# Technical Service Bulletin

## 17 Engine oil consumption too high, 2.0L TFSI (EA888) Model Year 2009 - 2011

17 15 54 2027731/6 January 29, 2015. Supersedes Technical Service Bulletin Group 17 number 13-43 dated October 16, 2013 for reasons listed below.

**Figure 1.** 01 – Oil consumption measurement (electronic measurement).

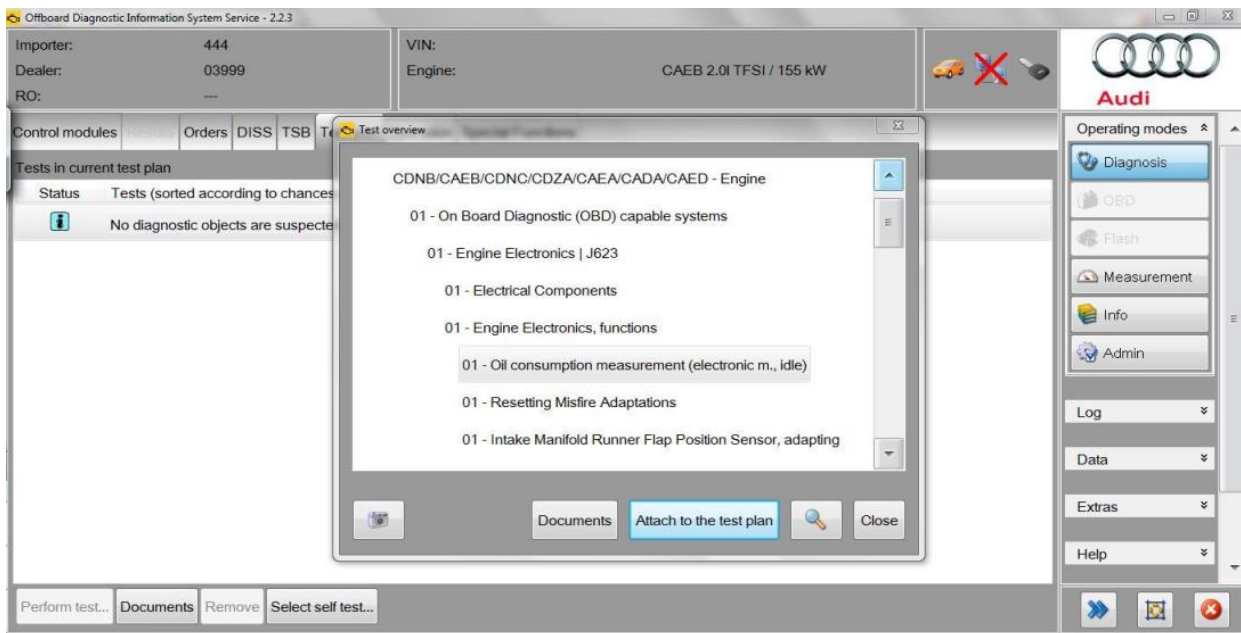
- **Park vehicle on a level surface, the GFF test plan will *not* continue if vehicle is tilted more than 0.5 degrees (*side to side or front to rear*).**
- Start Diagnosis. *Select Self-test >> Powertrain (repair groups 10-39) >> 01 On Board Diagnostic (OBD) >> 01 Engine Electronics >> Engine Electronics, functions >> 01 Oil consumption measurement (electronic m., idle).*

- Follow the GFF test plan, *Start oil consumption measurement* exactly and observe all notes and cautions.
